**MONTGOMERY COUNTY HISTORIC PRESERVATION COMMISSION**  
**STAFF REPORT**

<b>Address:</b>	10212 Montgomery Ave., Kensington	<b>Meeting Date:</b>	1/10/2024
<b>Resource:</b>	Primary One Resource <b>Kensington Historic District</b>	<b>Report Date:</b>	1/3/2024
<b>Applicant:</b>	Warner Circle Mansion Condominiums, LLC (Karl Voglmayr, Agent)	<b>Public Notice:</b>	12/27/2023
<b>Review:</b>	HAWP	<b>Tax Credit:</b>	Partial
<b>Permit No.:</b>	1032588 REVISION	<b>Staff:</b>	Dan Bruechert
<b>Proposal:</b>	Post-approval revisions for comprehensive rehabilitation, new addition, site alterations and grading

## WARNER MANSION RENOVATION & ADDITION – HPC REVIEW

4 CARRIAGE HOUSE - WEST ELEVATION  
SCALE: 1/4"=1'-0"

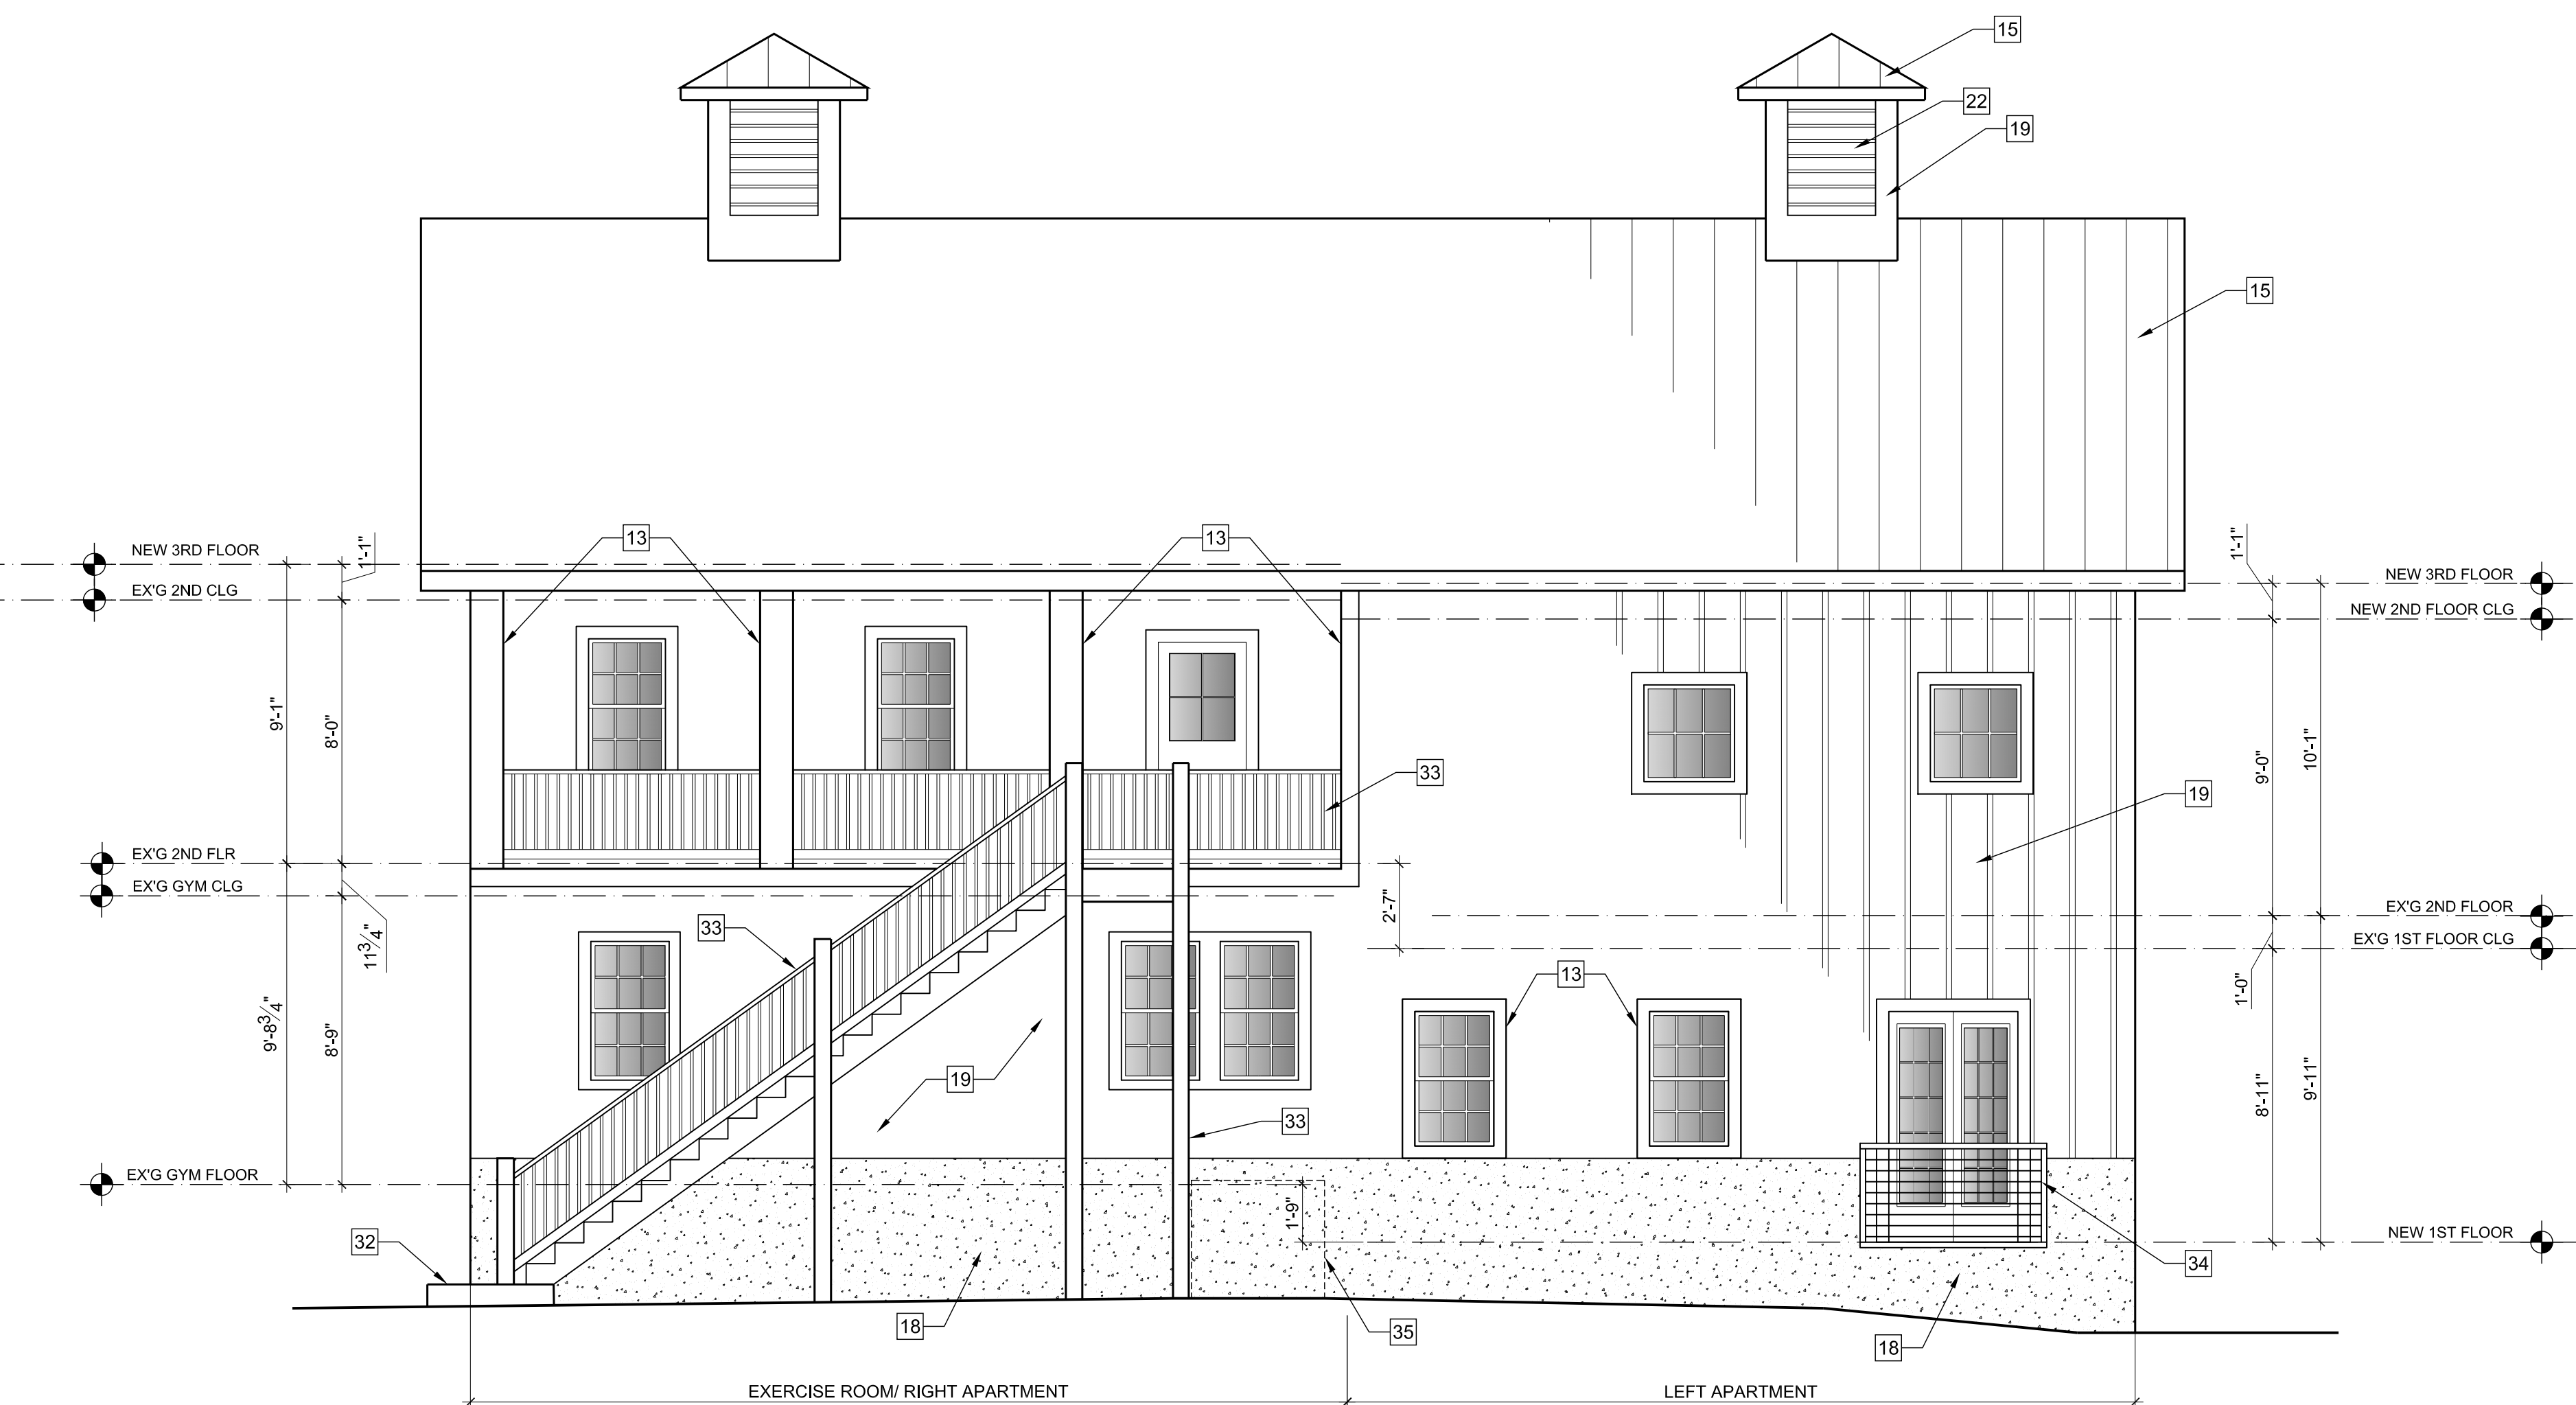
6. 3<sup>rd</sup> Floor Window Raised, enlarged for egress – The existing opening on the west elevation has a louvered opening. The applicant proposes removing the louvers and installing a pair of eight-light casement windows which will satisfy code requirement for egress. Staff finds removing virtually all of the louvered openings has the potential to negatively change the character of the historic carriage house contravening 24A-8(b)(2) and Standard 2. Staff recommends the HPC not allow this change and recommends the applicant consider alternative solutions, such as a skylight, on the south roof slope or other floorplan revision.

8. 3<sup>rd</sup> Floor Window Raised – As with the 3rd-floor window on the west elevation (#6, above), the applicant proposes to remove the louvered opening and install a pair of 8-light casement windows in the opening. The previous HAWP approval included installing a large sash window in the opening. However, the sill of that window appears to be too close to the floor (see *Figures 2-4*, below). . Based on the drawings submitted, Staff cannot evaluate the size of the proposed window compared to the previous approval. Staff finds the relocated window negatively impacts the fenestration on the east elevation and recommends the HPC not approve the alteration.

1. For the Carriage House, some windows have been enlarged or slightly re-positioned. See the clouded areas on sheet A002.
2. The solar panels have been deleted from the south Carriage House roof as shown on Sheet A002.

3. The existing ramp has been deleted from the south side of the Carriage House as shown on Sheet A002. The concrete is in a state of extreme disrepair and code would require guardrails of some kind on each side if rebuilt or repaired.

2. The approval of these revised work items does not extend to the proposal to remove the louvered opening on the third floor and convert it into a window (work item #6). This opening should be retained, though glazing may be installed behind the louvers. If necessary alternative means of egress can be accommodated including a skylight on the south roof slope. Revised elevations and floorplans showing this condition has been satisfied need to be submitted to Staff to verify this condition has been satisfied.

3. The approval of these revised work items does not extend to relocating and reconfiguring the 3rd-floor window on the east elevation (work item #8) from the June 16, 2023 HAWP approval. As with work item #6, the opening size and placement need to be preserved.
